CLARK COUNTY, NEVADA BID NO. 603680-15 TRAFFIC SIGNAL SYSTEM AT LAKE MEAD BOULEVARD AND SLOAN LANE

ADDENDUM NO. 2

CONTRACT DRAWINGS L-2073

**TRAFFIC CONDUIT
TRENCHING DETAIL**

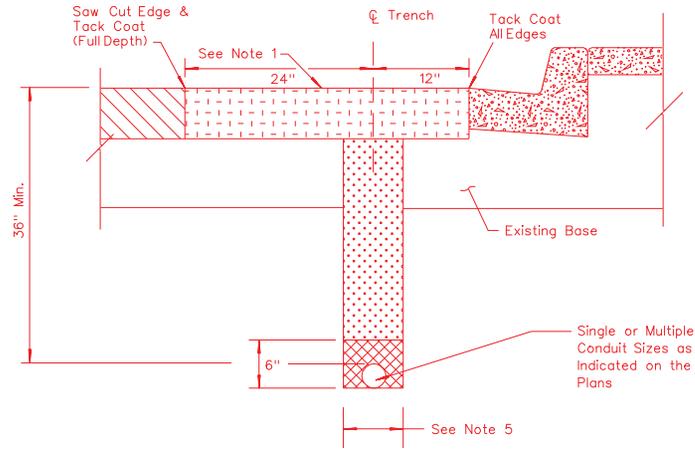
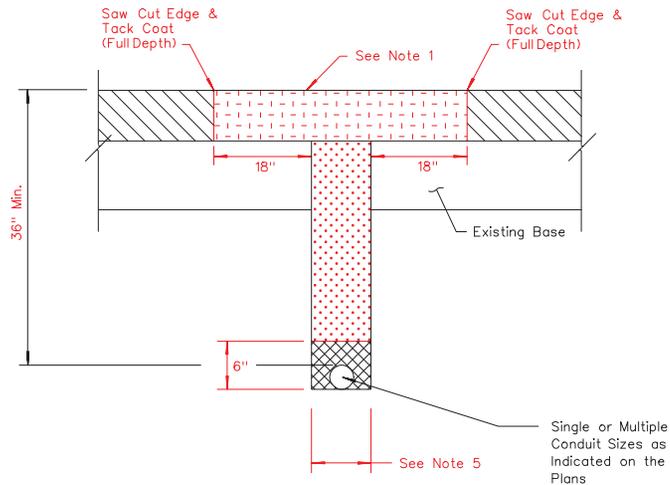
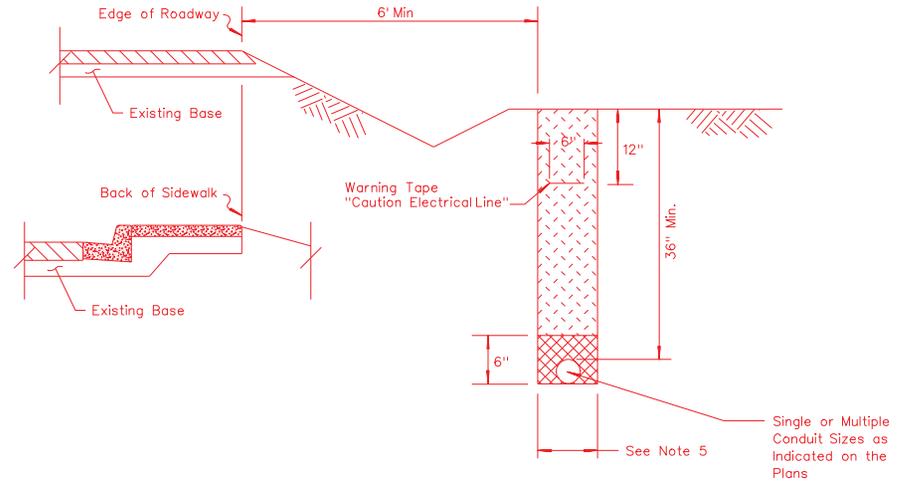
b) **Revised** NDOT trench details see attached detail E & F.

a) **Revised** trench section per NDOT T-30.1.2.1 to be 3' width to match revised NDOT trench details, see attached detail E & F.

a) **Revised** trench section per NDOT T-30.1.2.1 to be 3' width to match revised NDOT trench details, see attached detail E & F.

C TRENCH BACKFILL DETAIL
IN PAVED AREAS
 (LONGITUDINAL) NTS

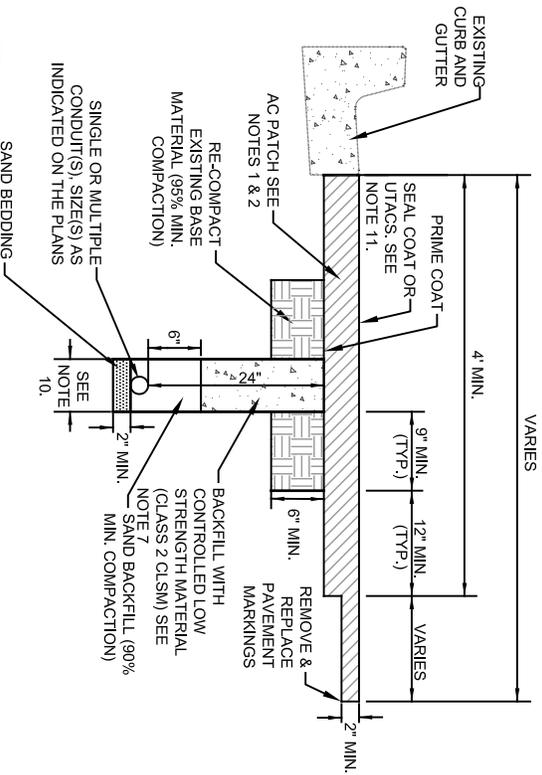
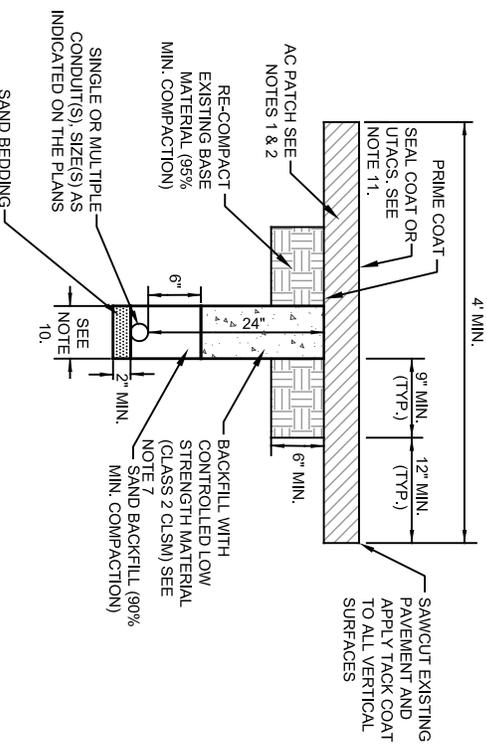
a) **Revised** County trench details see attached detail C & D.
